Item ID: D212-664-201TRN

Item Name: Crosstube Turning Detail

DART AEROSPACE LTD	Work Order: 99472
Description: Crosstube Assembly (205/212 High Aft)	Part Number: D212-664-241
Inspection Dwg: D212-664-241 Rev: D	Page 1 of 2

DRAWING NO. D212-664-241	TITLE CROSSTUBE ASSY (205/212 HI AFT)	REV. D	DART AEROSPACE LTD ENGINEERING ORDER		D.E.O. NO. D212-664-241-D-1	SHEET NO. SHEET 1 OF 2	SCALE NTS
DRAWN	CHECKED	MFG. APPR.	APPROVED	DE APPR.			
DATE 11.04.07	DATE 11.04.11	DATE 11.04.12	DATE 11/04/12	DATE 11.04.12

**D212-664-241-241B
ASSEMBLY DETAIL**

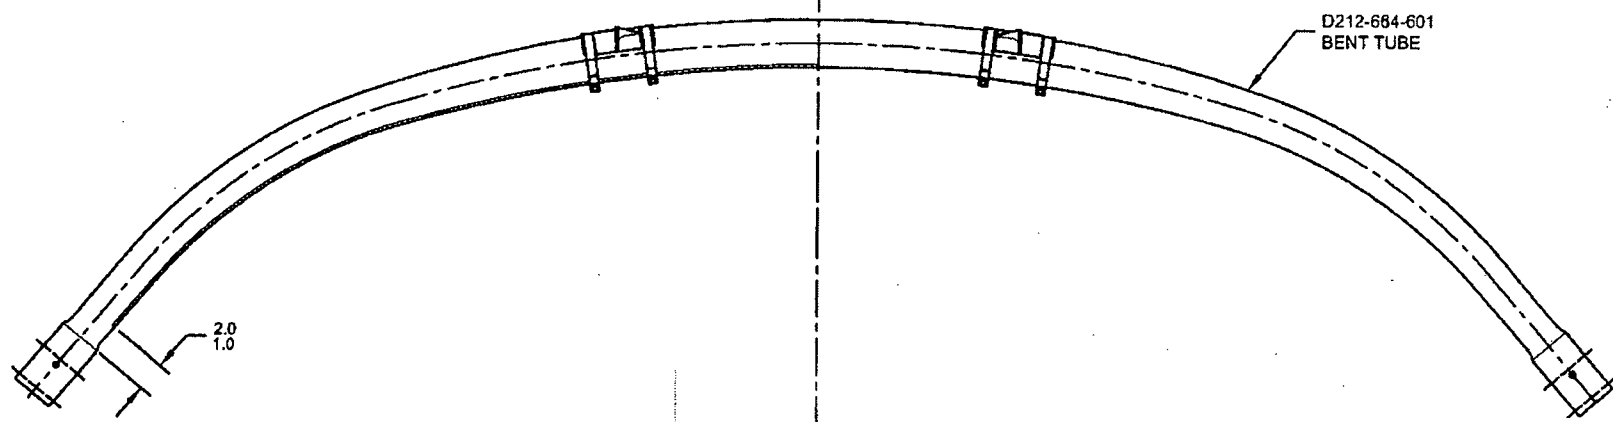
PURPOSE:

ADD AN INSPECTION WINDOW TO UNDERSIDE OF CROSSTUBE.

NOTES 2 OF SHEET 1 IS AMENDED AS FOLLOWS:

IS:

- 2) FINISH: CHEMICAL CONVERSION COAT PER DART QSI 005 4.1
PRIME INSIDE AND OUTSIDE PER DART QSI 005 4.2
MASK UNDERSIDE OF CROSSTUBE AS SHOWN (HATCHED AREA) AND
PAINT OUTSIDE PER DART QSI 005 4.2
REMOVE MASKING AND APPLY CLEAR COAT

WAS:

- 2) FINISH: CHEMICAL CONVERSION COAT PER DART QSI 005 4.1
PRIME INSIDE AND OUTSIDE PER DART QSI 005 4.2
PAINT OUTSIDE PER DART QSI 005 4.2

MASK AREA PRIOR TO PAINTING,
REMOVE MASKING AFTER PAINT
AND APPLY CLEAR COAT
